BUCKEYE HILL (MINOR PLAT)

SUMMARY

PROPOSED
PLAT

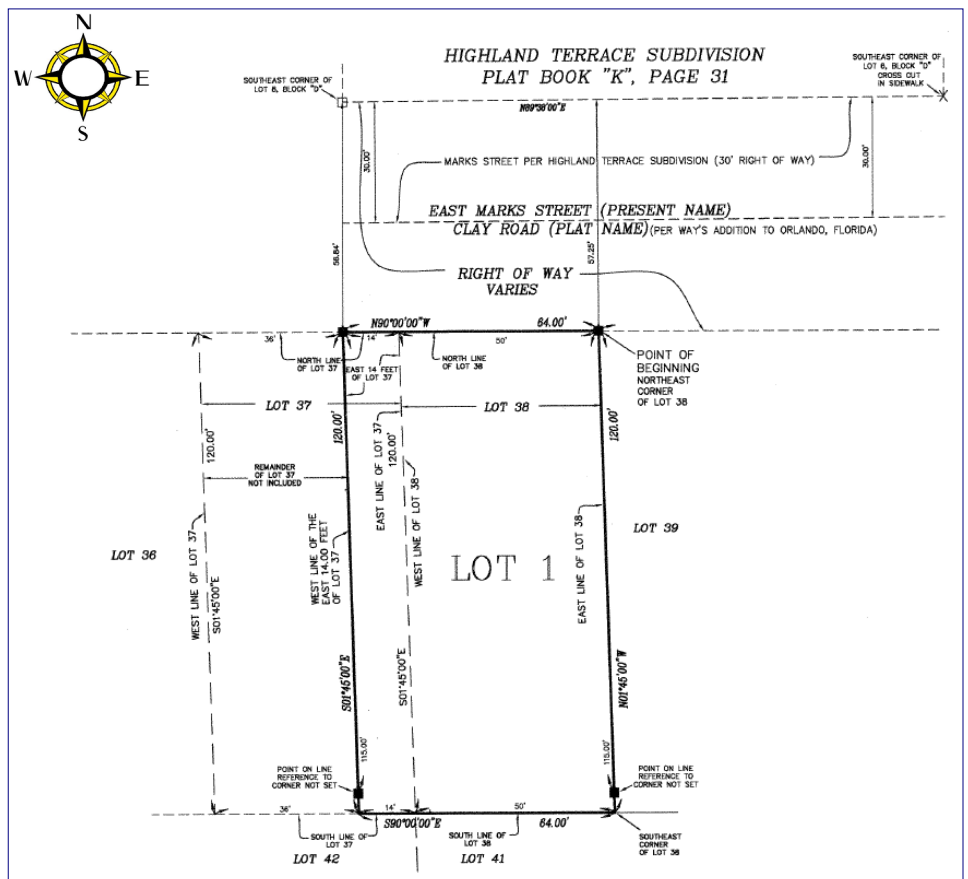
1. The record owner must be shown in the dedication: Ohio River Collieries Company, and Ohio corporation
2. A joinder & consent is required for the mortgage recorded in 8321/899
3. The dedication appears to dedicate an "easement shown hereon" but nothing is shown.
4. Please have the surveyor provide a one-and-the-same letter certifying the legal description shown on the plat describes the same area as the legal description shown on the title opinion.

1. Except as provided herein, the proposed plat is subject to all codes and ordinances of the State of Florida, City of Orlando, and all other applicable state regulatory agencies. Any applicable state or federal permits must be obtained before commencing development.
2. Continued development/redevelopment of the property shall require building permits prior to construction.
3. As the replatted parcel will straddle the R-2A/T and R-1/T each section will be subject to the setback requirements of the zoning in which it is located. At the time of this report the eastern 50 ft. is located in R-2A/T and the western 14 ft. is located in R-1/T. The side yard setbacks for R-1/T is 6ft. and R-2A/T is 5ft..

Plat Face Changes - There are a number of changes required to the face of the plat. In addition to the changes required on the plat, the following is a list of additional requirements.

- 1) Changes to the face of the plat.(A copy has already been returned to the surveyor).
- 2) Recording Fees (Checks should be made payable Orange County Comptroller.)
- 3) The plat must be reviewed by Orange County prior to recording. Begin this process by taking a copy of the executed plat to Room 1700 (Orange County Property Appraiser's Office, Attn. Rocco Campanale), 200 S. Orange Avenue, Sun Trust Bank Center. The original completed Statement of Lien from Orange County is required by this office. The Statement of Lien must be received by this office prior to recording the plat.
